OBJECTION TO THE PROPOSAL SSD 5752

The Proposal SSD 5752 Sydney International Convention, Exhibition and Entertainment Precinct - Redevelopment of convention centre, exhibition centre, entertainment facilities and associated public domain works

**Proposed
June 21 Winter
9:00am**

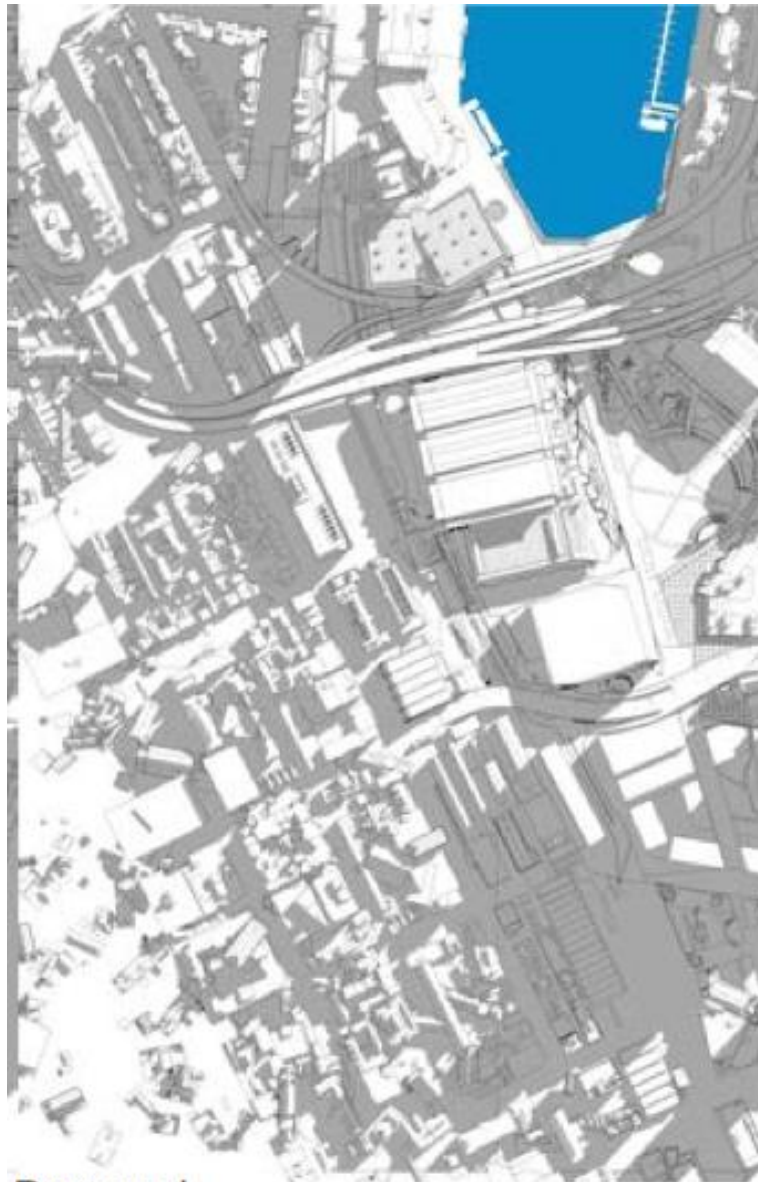
The ICC shadow diagrams show that there will be significant overshadowing of the Goldsbrough from the new ICC and towers, taking away morning sunlight in the all important winter mornings. This will result in increased heating costs for the apartments as well as the loss of valuable morning winter sunlight.

From the Shadow analysis diagrams in the DA it shows a significant loss of sunlight on Pymont St in front of the building and the Eastern face of the Goldsbrough in winter. This is in direct contradiction on trying to make Sydney's buildings more environmentally friendly.

See Shadow diagram below from DA submission.

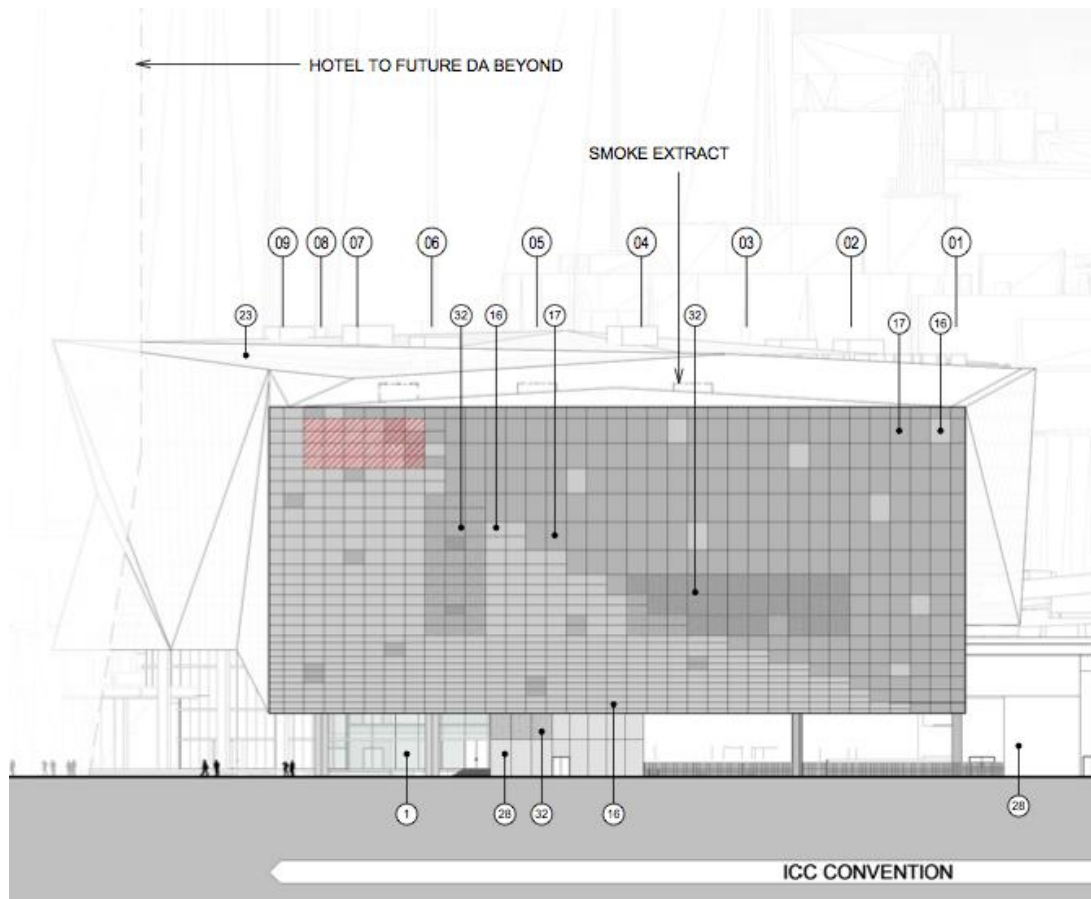
As the height of the proposed ICC is nearly the current height of the Goldsbrough, any outlook from the Goldsbrough to Darling Harbour will be dominated by the Western (rear) face of the ICC. In the DA plans it shows that this will be a Grey metal panel wall which will just look like a Grey metal barricade for the residents and visitors to Goldsbrough building and the visitors walking along Pyrmont Street. The glass frontage is kept for the Eastern (Darling Harbour) face of the building. All the publicity shots show the view of the East face yet all the Goldsbrough residents and the visitors to the area will see is the ugly utilitarian Western face.

If a proposal for a building is allowed to go ahead, the proposed ICC building height should be the same level of the existing building and the Western face of the ICC should be architecturally articulated and made of materials (e.g. glass) that don't look like a metal barricade.

See Diagram below for view of the Western face of the ICC facing the Goldsbrough. Note the scale of this wall in relation to the people in the picture.

The mentioned walkway

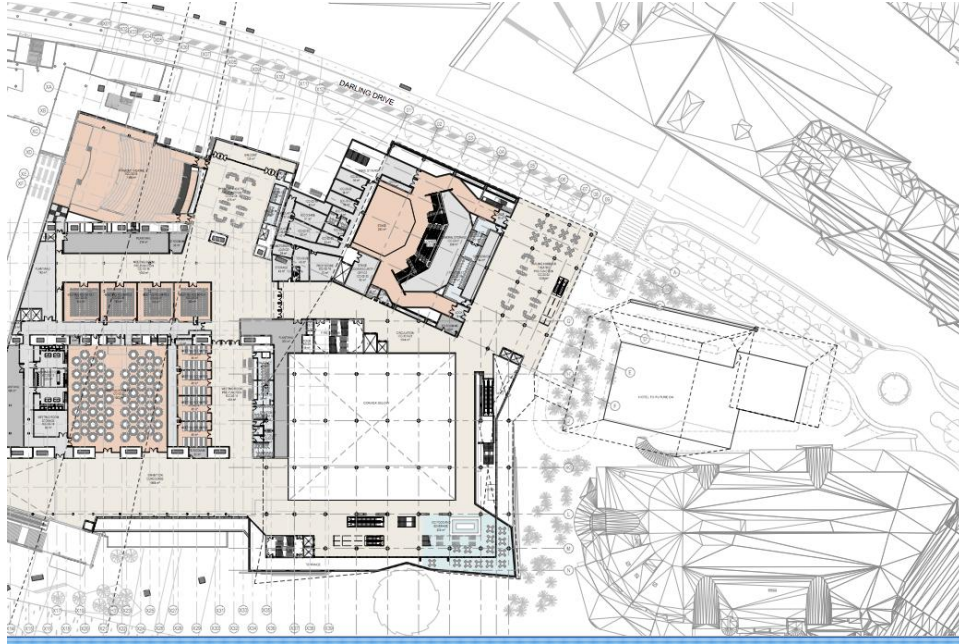
The proposed changes at Darling Harbour seem to take away an extremely important thoroughfare for the residents. From the plans it looks like the current overhead pedestrian walkway next to the Convention monorail station is being removed. Currently it is the easiest and safest walkway to enter the Darling Harbour precinct from the Western side. Currently it is estimated that there are around 7000 pedestrian traffic movements across this walkway on a regular day and many more on busy event days. It is the only safe way to cross the light rail tracks and Darling Drive and is the direct access for 2 major car parks servicing Darling Harbour. This walkway is open 24 hours a day, 7 days a week with continuous public access.

How are pedestrians especially with children and elderly people meant to cross to and from Darling Harbour in a safe way at all hours?

From the Architectural drawings below it shows how the current walkway is removed in the proposed plan
